Attachment E

Submissions

Subject: Submission - D/2023/1036 - 87 Lower Fort Street MILLERS POINT NSW 2000 - Attention Marie Burge

Sketch Image 1-Southern Boundary to Lower Fort Street

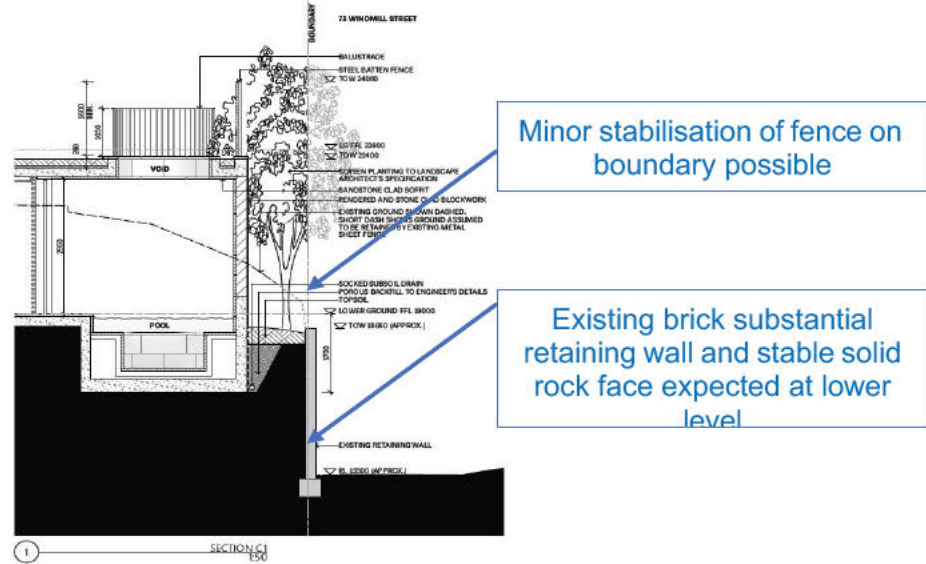
The structural report review does not consider the full length of the retaining wall at 67 and 69 Windmill Street and how the retaining walls will be impacted by the development. The report addresses 73 Windmill Street only as shown on the image below. The heritage retaining wall is not a substantial brick wall in the other properties as outlined above and there is no detail in how the retaining walls are satisfactory for the proposed development. The information shown is incorrect. The existing retaining wall is shown incorrectly and does not represent what is on site.

The architectural drawings show a section of the retaining wall of 69 Windmill Street, however this is also based on incorrect information on the wall.

There has not been any considered investigation in regard to the removal and excavation for the proposal nor the load from the proposed redevelopment including the landscape treatment on the entire retaining wall that adjoins the boundary. We note the landscape treatment is to provide better amenity to the adjoining landowners (which we discuss further below). However, there has not been a considered investigation in regard to whether the retaining walls, that is part of the CMPs for all properties, will be impacted by the landscape proposed. Neither the structural review nor geotechnical report discuss the potential impacts of the landscape treatment.

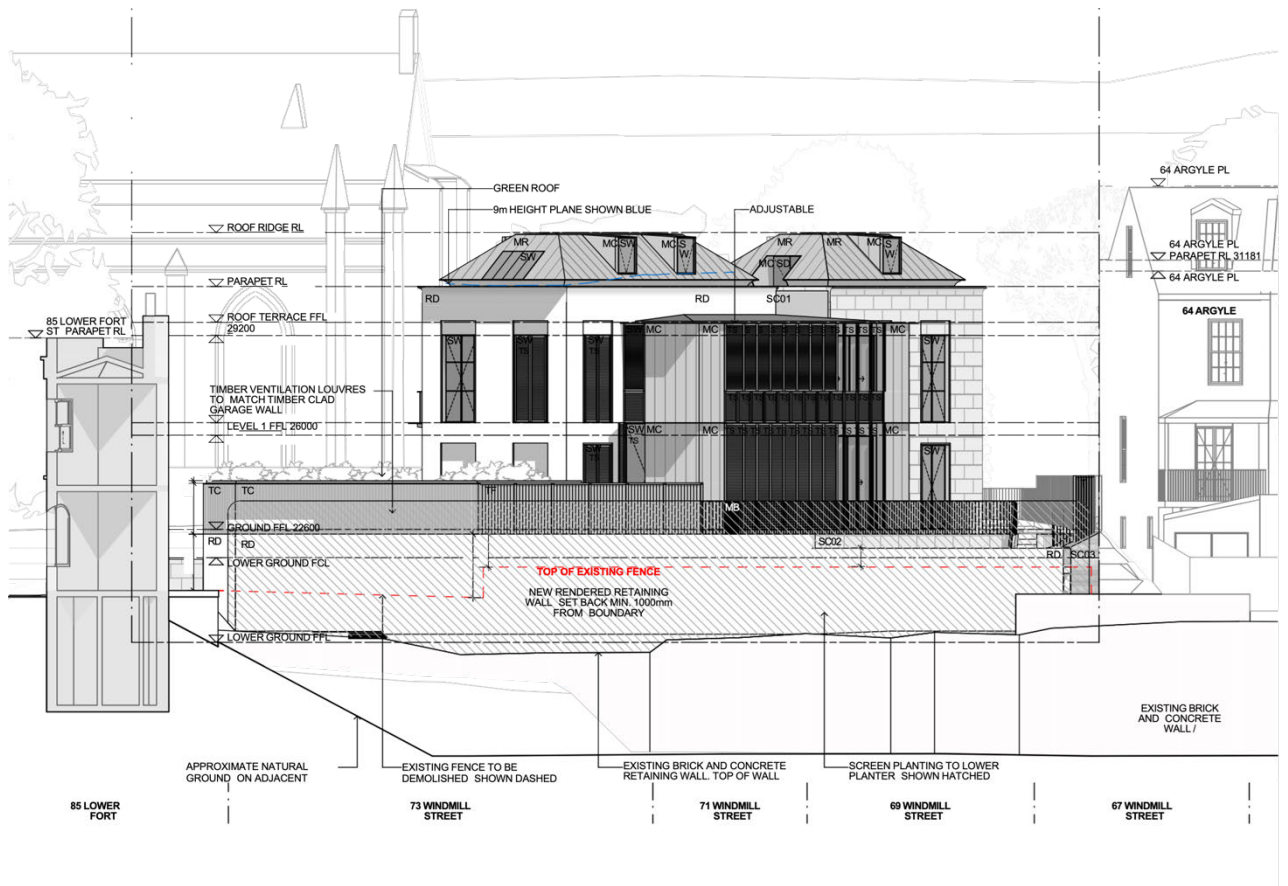
The proposed development does not meet the requirements of the DCP as it has sill heights lower than 1.4m, all windows are opening and to full widths, glass doors are also proposed to open to full width and the building is orientated, which will look directly into our dwelling and we will look directly into the proposed dwelling. Whilst there are screening devices, these are fully adjustable and do not provide any visual privacy for the occupants or us.

Figure 2: Proposed South Elevation (Source - Andrew Burns Architecture)

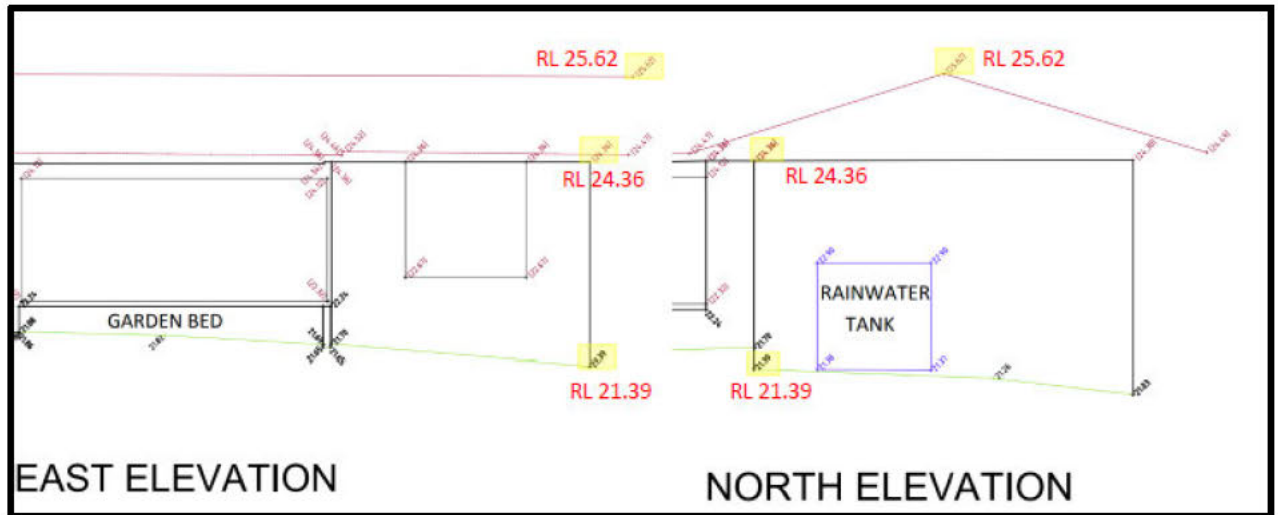
Given the maximum building height of 4.23m, the proposal exceeds the requirements as prescribed under Clause 6.47(5) by 252.2%. The variations are detailed in **Figure 1 and 2** below.

Figure 5: Proposed south elevation showing windows facing 64 Argyle Place (Source: Andrew Burns Architecture)

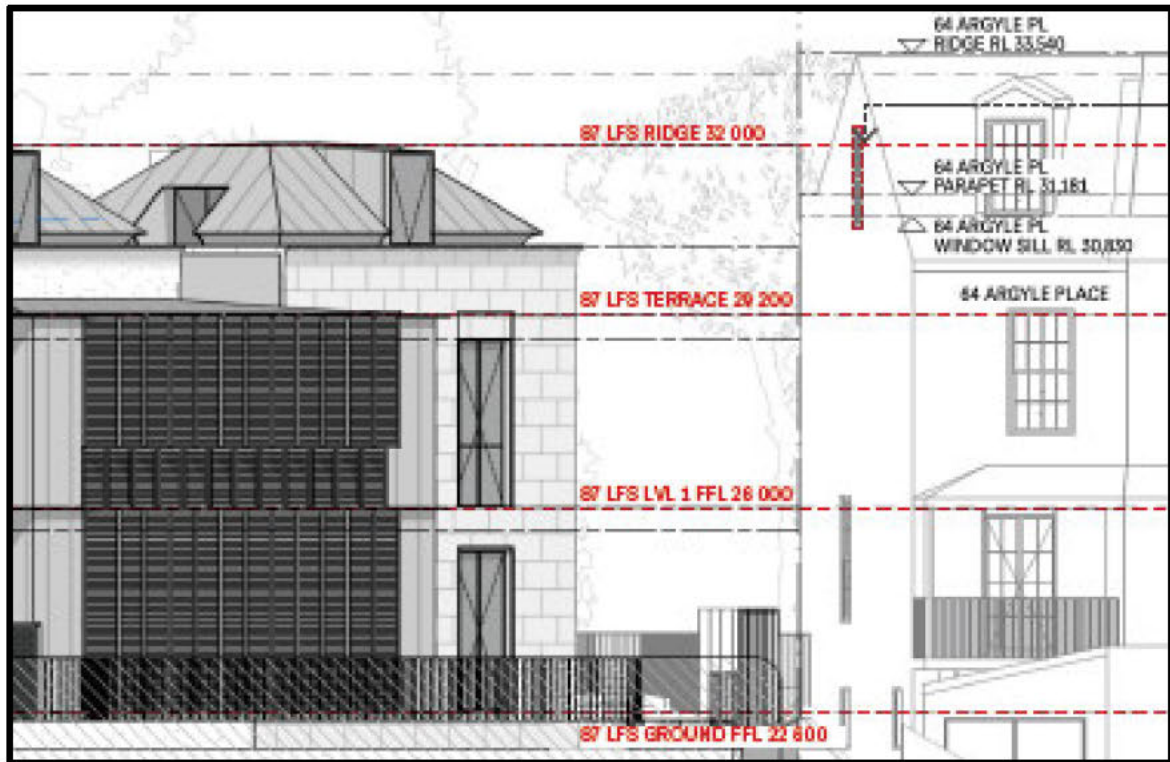
The proposed development has not been designed to adequately manage potential overlooking or visual privacy impacts on our client's property. As demonstrated in **Figures 4 – 9**, our client's property is situated to the west.

The proposed design of the development includes a number of windows to the rear elevation/side that face our client’s property and does not comply with the key controls or objectives of Section 4.1.3.6 of the DCP. Specifically, the windows on the southern elevation (View 6) as illustrated on **Figure 8** and **9** proposes large expansive openings which have not been adequately offset. These windows permit direct and intrusive viewing towards habitable windows on our clients ground floor and first floor windows and doors.

Figure 10: West Elevation (Source: Andrew Burns Architecture)

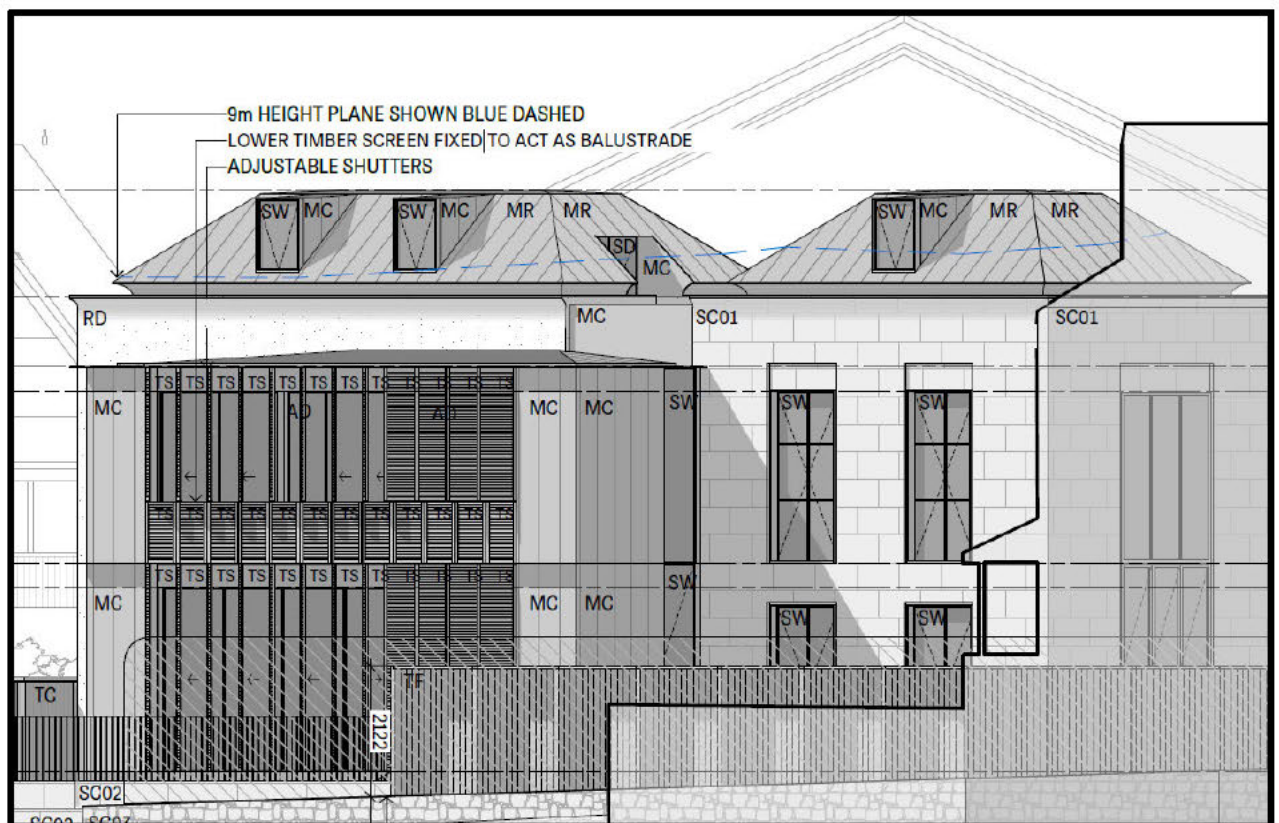
With regard to the proposed upper-level windows along the rear elevation, objection is raised due to the potential for adverse overlooking impacts to our client’s private open space (POS). **Figures 8** and **9** above details potential view points towards our client’s property at 64 Argyle Place, Millers Point and **Figure 10** below details the first-floor windows of concern.

The applicant contends that a 'combination of view angling, screening and screening vegetation has been employed to preserve privacy'. However, insufficient information has been lodged with the application to demonstrate that first floor windows avoid sightlines towards our clients POS. Specifically, the windows adjoining the bedrooms 2 and 4 (View 8A, 8B & 9) are considered to be excessive noting they directly face our clients POS. At a minimum, the lower timber screen fixed to act as balustrade should extend to a height of 1.4m above finished floor level and/or the shutters shall be permanently fixed, or remaining openings be 60% obscure.

Figure 13: View towards 64 Argyle Pl. (Source: Andrew Burns Architecture)

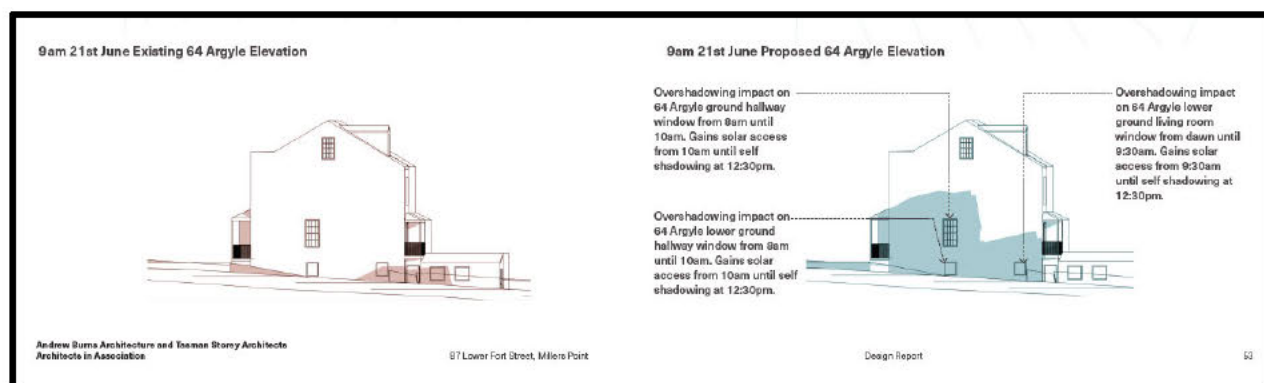
The proposed development involves the demolition of existing structures, site excavation and the construction of a new dwelling with associated landscaping. As shown in **Figure 13**, the proposed development will unreasonably cast additional overshadowing on the adjoining development to the west.

Specifically, the proposed development results in additional overshadowing impacts towards the lower ground hallway, lower ground living and ground hallway of 64 Argyle Pl between 9am and 12pm. The applicant has advised that these components gain solar access from 10am until self-shadowing at 12:30pm. However, the shadow diagrams submitted as part of the application only show detail every 3 hours and do not illustrate any solar access gained as a result of the proposed development. The applicant also proposes significant landscaping along the boundary that have the potential to cast additional overshadowing on our client's site. Overall, the proposed development has failed to adequately meet their evidential burden.

Figure 15: View from 64 Argyle attic window– existing (Source: Andrew Burns Architecture)

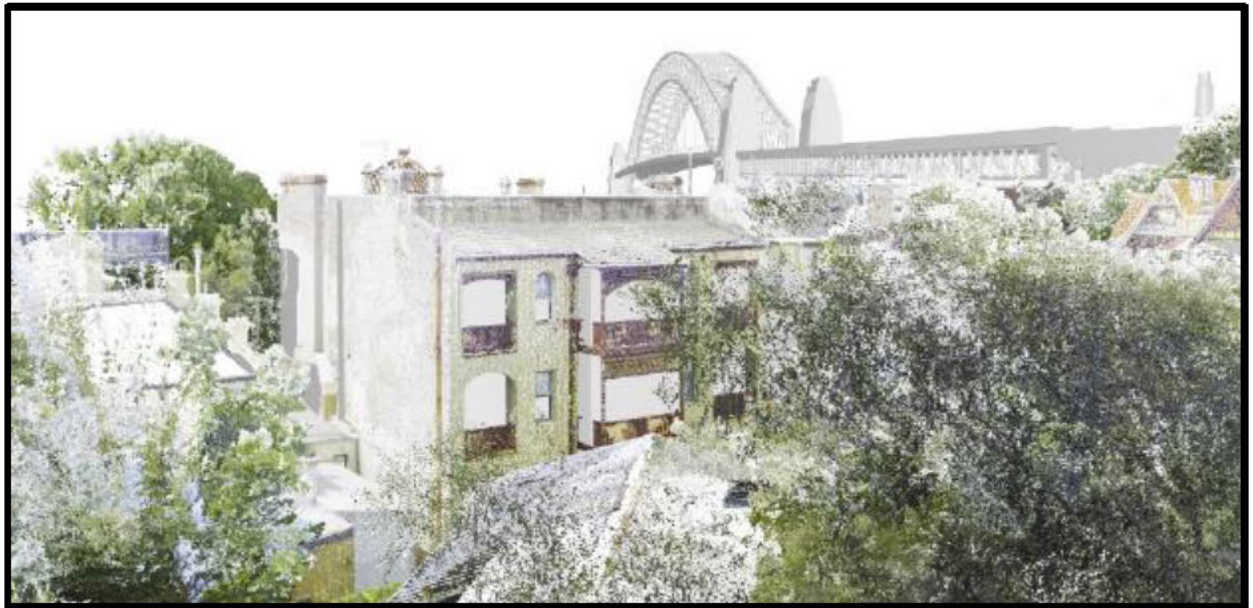
Figures 15 and 16 demonstrates what part existing views are obtained, being from the attic windows of 64 Argyle Street.

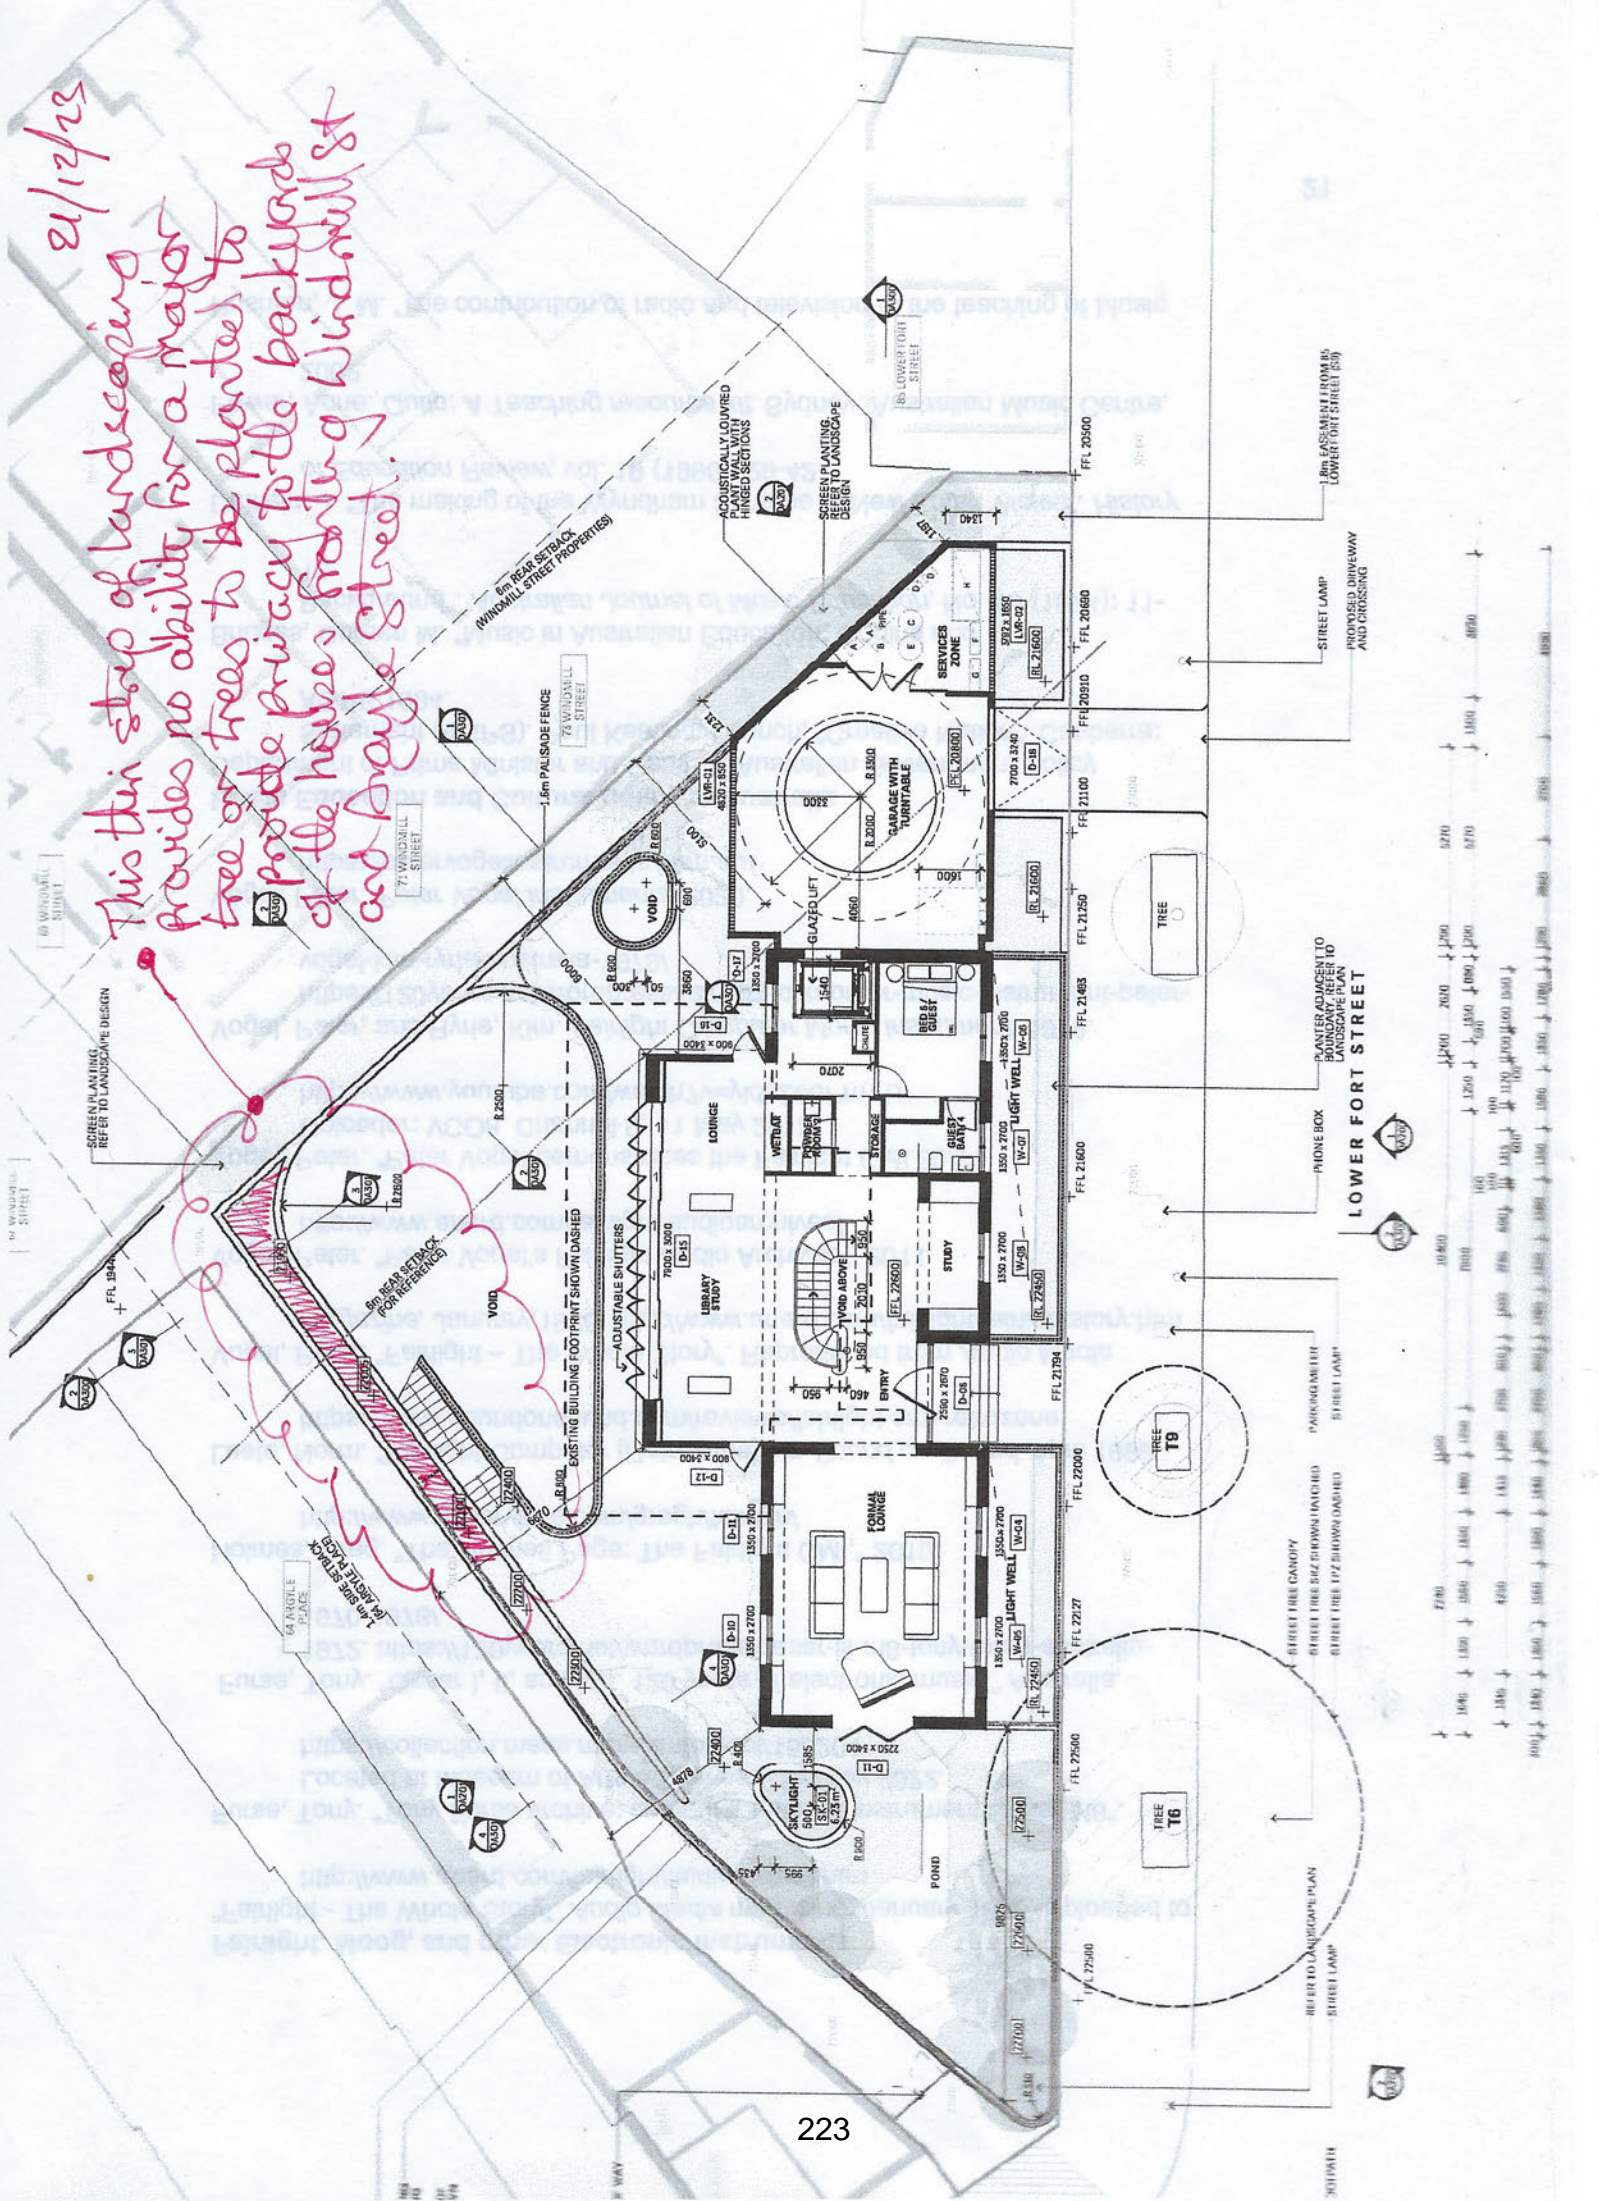
This thin strip of landscaping provides no ability for a major tree or trees to be planted to provide privacy to the backyards of the houses fronting Windmill St and Angyle Street.
